## Proposal for amendments to Regulation No. 43 (Safety glazing)

The text reproduced below was prepared by the expert of CLEPA to amend figure 2a of Annex 18 to better reflect the meaning of paragraph 2.4.2.2 of Annex 18 mainly in respect to the lateral limits of any opaque obscuration in this area. The modifications to the current text of UN Regulation No. 43 are marked in bold for new characters and strikethrough for deleted characters.

Annex 18, Figure 2a, replace by:

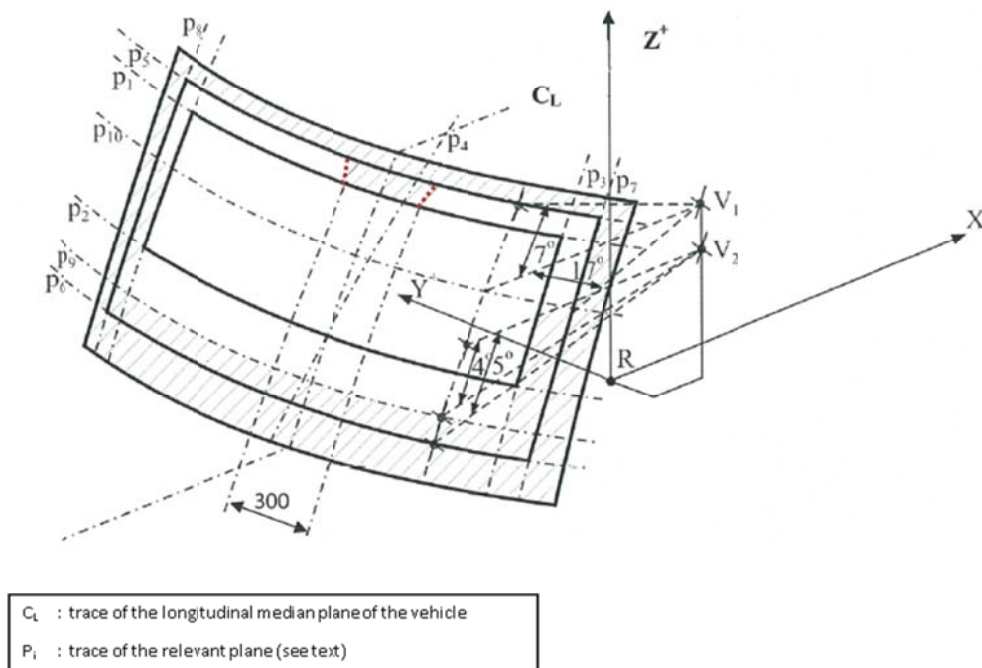
Figure 2a shall be modified to reflect the meaning of paragraph 2.4.2.2 mainly with respect to the lateral limits of any opaque obscuration in this area. The current figure would be correct only in case the inclination of the windscreen is 90° from horizontal – this case is more than unlikely.

These lateral limits are parallel to the traces of planes 4 and 4'. On the trace of plane 1 this leads to a boundary width of 300 mm centred on the longitudinal median plane of the vehicle ( $C_L$ ). The boundary width on the trace of plane 5 is given by the parallels to the traces of plane 4 and 4'.
